RESPONSE TO NRC LTR DTD 03/30/78... FURNISHING ADDL INFO IN SUPPORT OF
APPLICANT'S REQUEST FOR A 50% WASTAGE STEAM GENERATOR TUBE PLUGGING
LIMIT... W/ATT.

June 9, 1978

H. B. ROBINSON STEAM ELECTRIC PLANT UNIT NO. 2
DOCKET NO. 50-261
LICENSE NO. DPR-23
STEAM GENERATOR TUBE PLUGGING LIMIT

MEAN INDICATION GROWTH BETWEEN CONSECUTIVE INSPECTIONS
 AS A FUNCTION OF THE DATE OF THE LATER INSPECTION
 AT (CPL) H B ROBINSON 2, SG-A
 (ONLY INDICATIONS $\geq 30\%$ IN BOTH INSPECTIONS ARE INCLUDED
 IN THESE COMPARISONS)

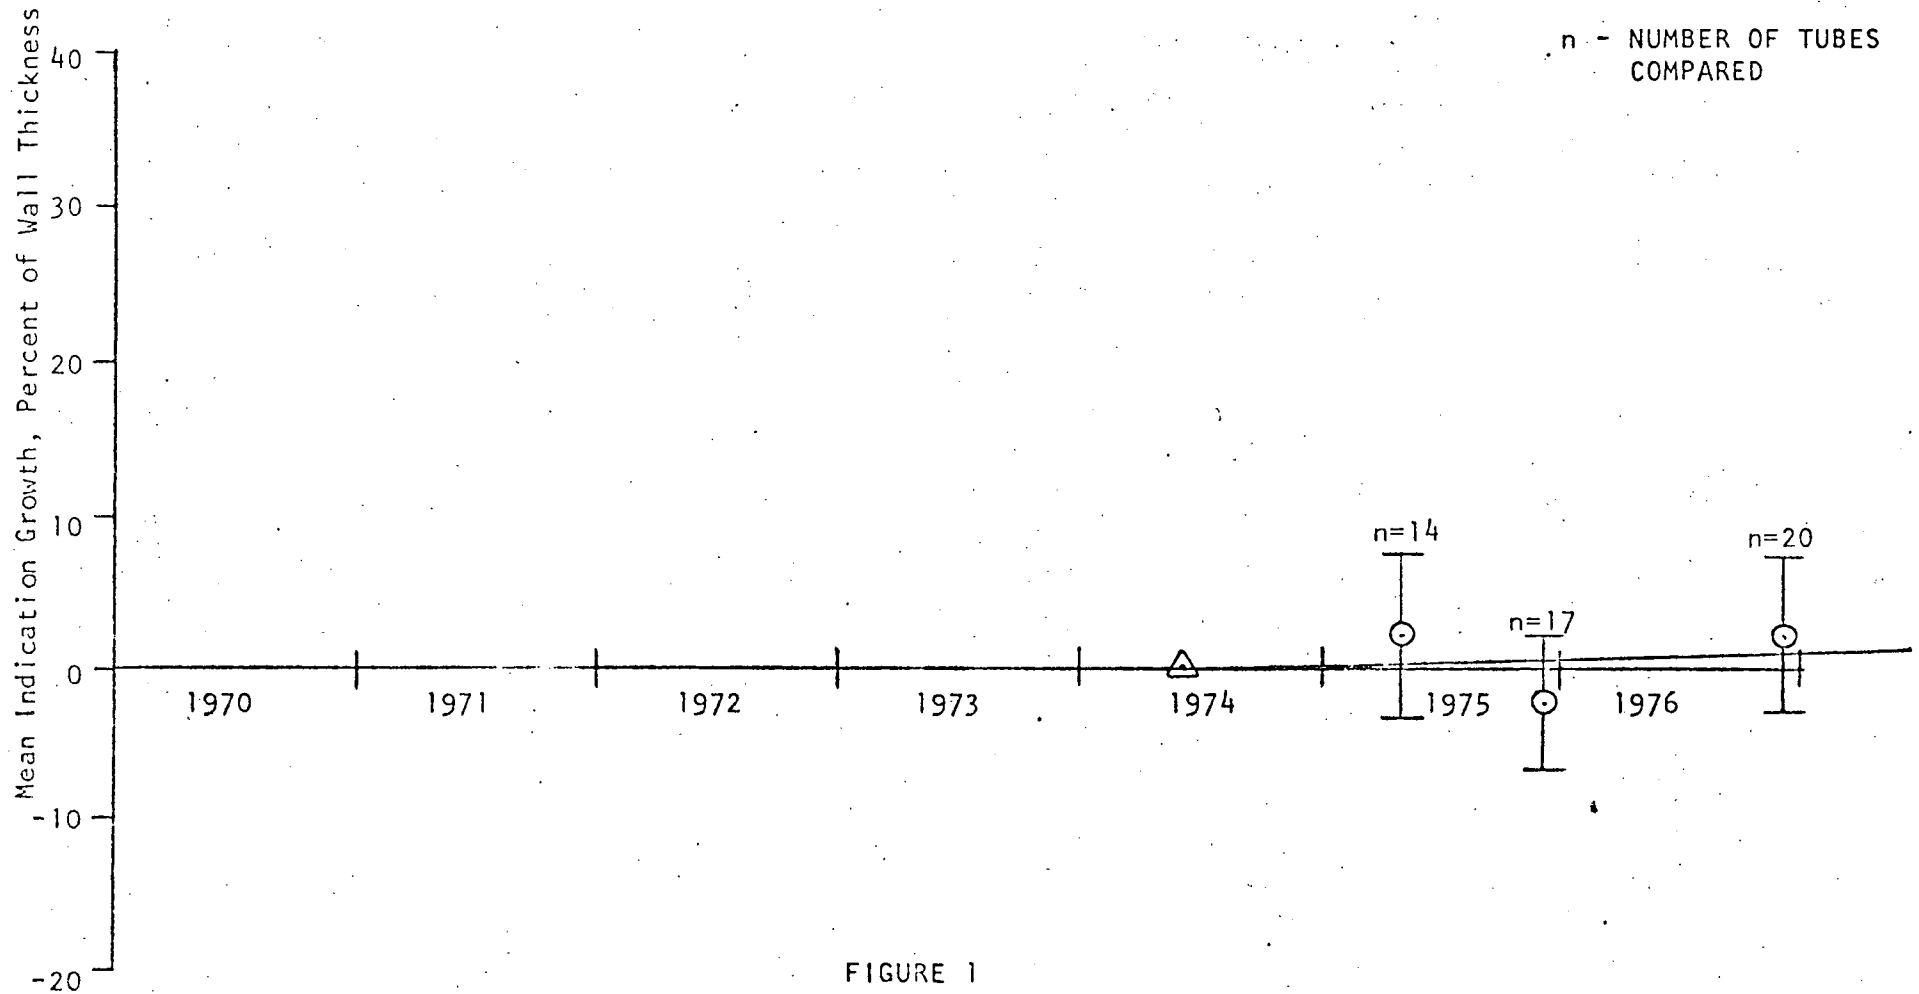
The data presented in Figures 36, 37 and 38 of Attachment I to the July 29, 1977 submittal, indicate relatively large standard deviations and instances of negative mean defect growth. Therefore, recalculate the mean defect growth between consecutive inspections using only those tubes with wastage of greater than 40% to the extent possible. This should minimize errors associated with the small eddy current indications. In addition to the three figures, provide a numerical tabulation of the mean and standard deviation for: 1) each of the three inspections of each generator; 2) each generator; and 3) the entire unit. Since a comparison of a significant sample of tubes must be made, it may be necessary to include tubes with defect indications of less than 40%.

Figures 1 through 4 plot the mean indication growth between consecutive inspections as a function of the later inspection, for each steam generator and for the entire unit. There were not enough comparisons to produce a meaningful sample if only those indications of $\geq 40\%$ were used. Therefore, in an attempt to reduce the errors associated with small indications, but still provide a meaningful sample size, indications $\geq 30\%$ were compared.

A linear regression analysis was performed on the four points plotted in each figure and the calculated lines were drawn. Note that these lines have negative slope in three of the four cases.
